MONROE COUNTY PLAT COMMITTEE

3. 1806-SPP-02 Emerald Trace Subdivision Major Preliminary Plat Amendment. PAGE 3

PLANNER Jackie Nester
CASE NUMBER **1806-SPP-02**
Emerald Trace Subdivision Preliminary Plat Amendment with Sidewalk Waiver along Lots 1, 2 & 3 and
Request to Remove Condition of Shared Driveway between Lots 1 & 2
PETITIONER Dan Moore in care of Smith Brehob and Associates
ADDRESS Emerald Trace - 2982, 2998, E Kylie CT and 4225 S Amber DR (Parcel #s: 53-08-22-400-031.003-008; 53-08-22-400-031.001-008; 53-08-22-400-031.002-008).
REQUEST Major Subdivision Preliminary Plat Amendment to request a sidewalk Waiver and Request for separate driveway between lots 1 & 2
ZONE Estate Residential 1 (RE1)
ACRES 20 acres +/-
TOWNSHIP Van Buren
SECTION 22
COMP. PLAN
DESIGNATION MCUA Suburban Residential, MCUA Phase II – Open Space (OS)

Superimposed sidewalk location and its impact on the wooded areas along E Kylie CT

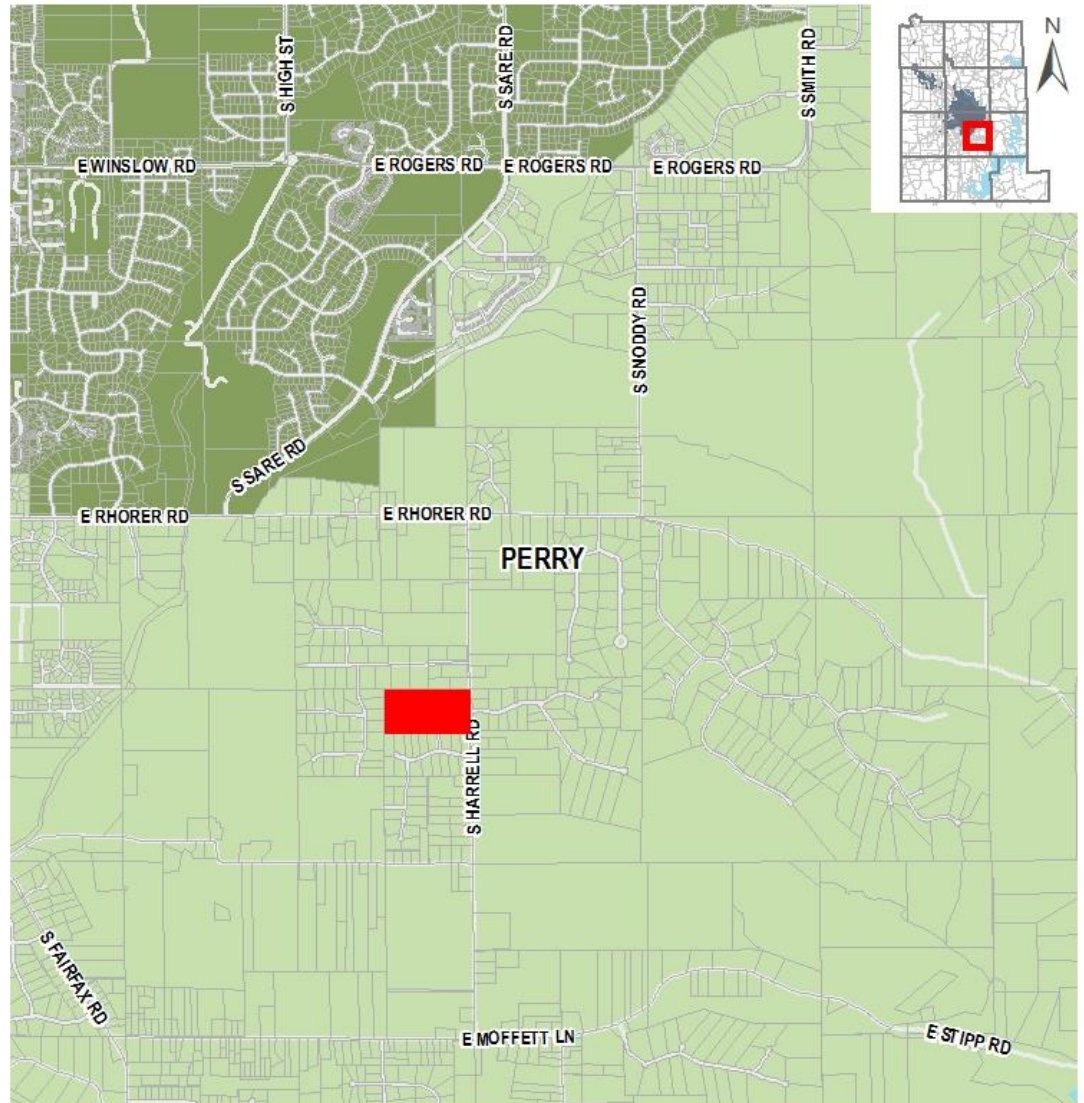
The Planning and Public Works Departments do not see an issue with the petitioner installing the sidewalks as required on the original preliminary plat approved in 2006. The current construction plans show a 4 foot concrete sidewalk to be installed along the right of way line. The location of the sidewalk would be approximately 5 feet from the curb along the roadways. The area where the sidewalk would go along E Kylie CT is not obstructed by wooded areas (see photos below). In addition, the condition that ¼ acre of trees along lots 1-3 be preserved will still be in effect.

The purpose of the condition to share a driveway between lots 1 & 2 was in order to protect the riparian conservancy area located on the properties. The riparian conservancy area was adjusted to accommodate the shared driveway location and S Amber Drive. By taking out the existing driveway and putting in two new driveways there would be grading work occurring near the riparian buffer.

Photo 10. Image showing where sidewalks and street trees are currently missing. Lots 1-3 are outlined in red to show that a sidewalk waiver is being requested.

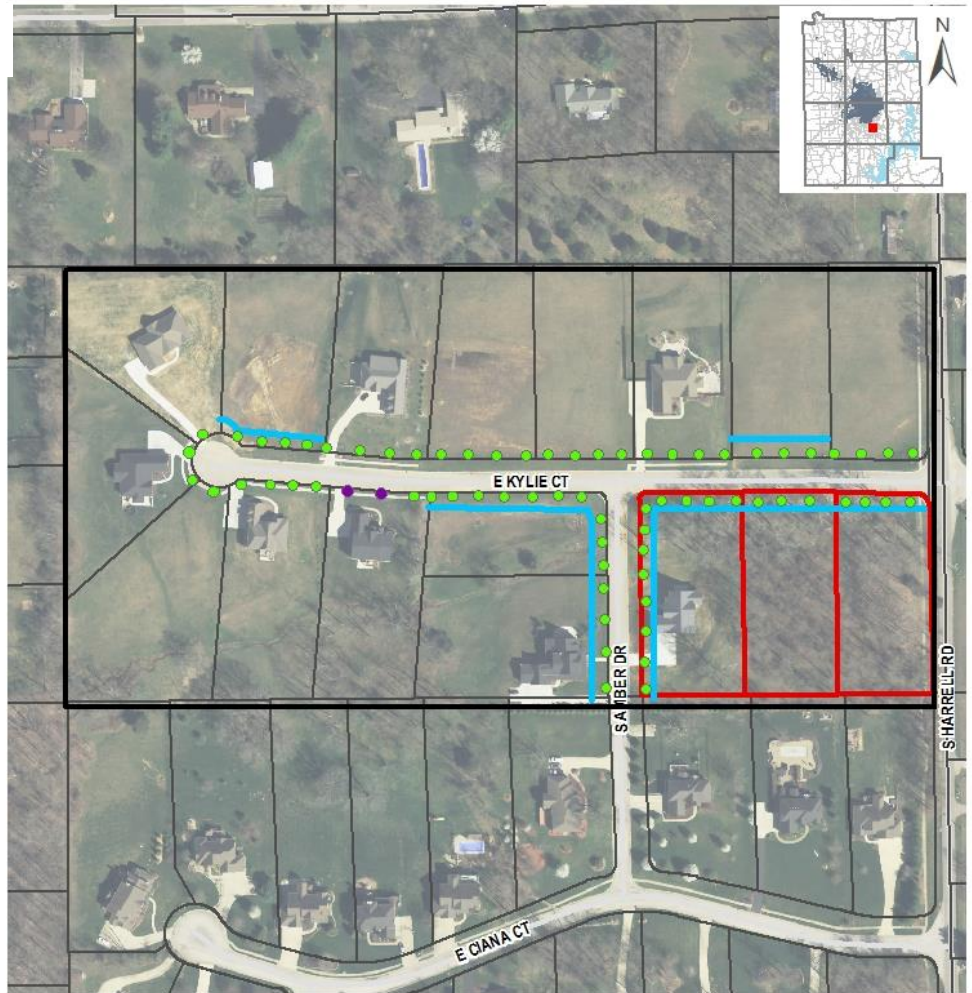
The subdivision to date has a bond on file for \$90,000 for street trees, sidewalks, and asphalt surfacing. The letter of credit was renewed April 3, 2018, and the new expiration date of the bond is April 3, 2019. To date, the following improvements **have not** been made:

Sidewalks: Requires additional approximately 1502 feet of sidewalk; 749 feet of the required sidewalk is requested to be waived.

Street Trees: 71 required, 69 still requiring installation

EXHIBIT 6: Proposed Preliminary Plat

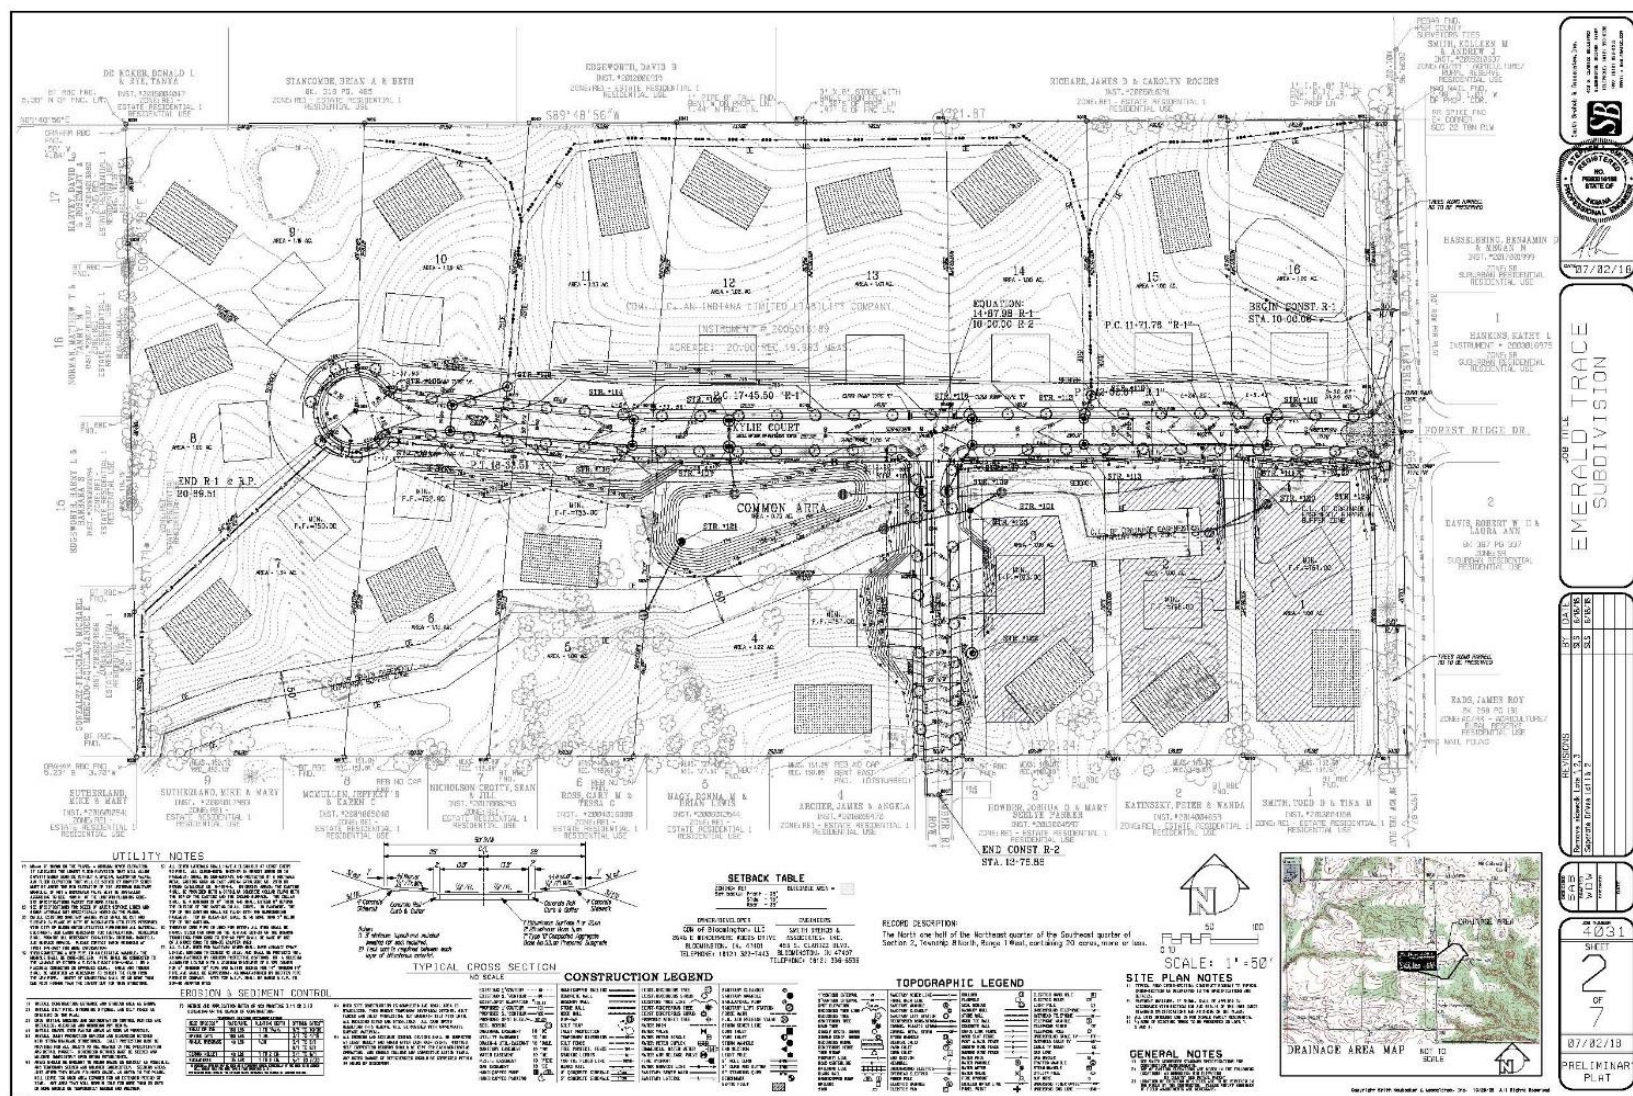
Sidewalk Waiver. The south side of Kylie Court and a portion of the east side of Amber Drive is low laying wooded drainage area. Construction of a sidewalk along those sections of road would disturb the wooded drainage area. There are sidewalks on the other side of both streets. The section of sidewalk sought to be deleted does not connect to another sidewalk in the subdivision to the south.. This section of sidewalk can be deleted and still have an effective pedestrian circulation plan and also protect the wooded drainage area.

Separate Driveways on lots 1 and 2. Prospective home owners have indicated a strong dislike of a shared driveway on otherwise pretty typical lots as illustrated by these two lots being the last ones not sold by the developer. If the Plan Commission does not grant the sidewalk waiver and thereby indicating a willingness to allow encroachment into the

wooded drainage area, then the owner would like to amend the 2006 approval to allow individual drives on these two lots. The driveway configuration is shown on the drawing included with this application.

Staff gives a recommendation of **denial** of the Major Subdivision Preliminary Plat, Sidewalk Waiver and Request for a separate driveway based on the findings of fact and subject to the Monroe County Highway Department and Drainage Engineer reports.
